AIRWORTHINESS DIRECTIVE

TYPE AFFECTED: ASW 24

SUBJECT: Modifications for the issue of an Australian Certificate of Airworthiness.

Figure 1.

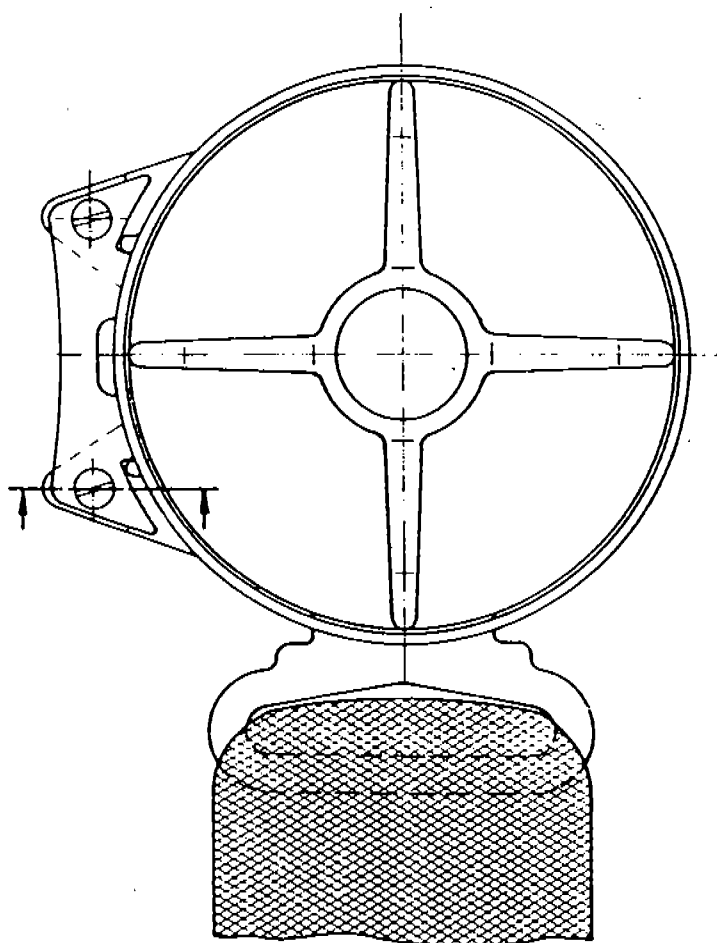
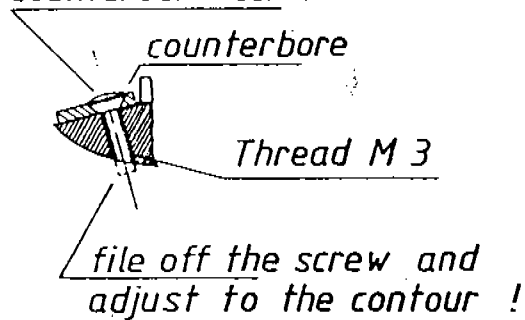
The Gadringer rotary lock harness must be modified by installing 2 screws as shown in figure 1 to prevent separate disconnection of the shoulder straps.

Countersunk screw M3 x 10 DIN 964 (use 'Loctite' to secure the screw)
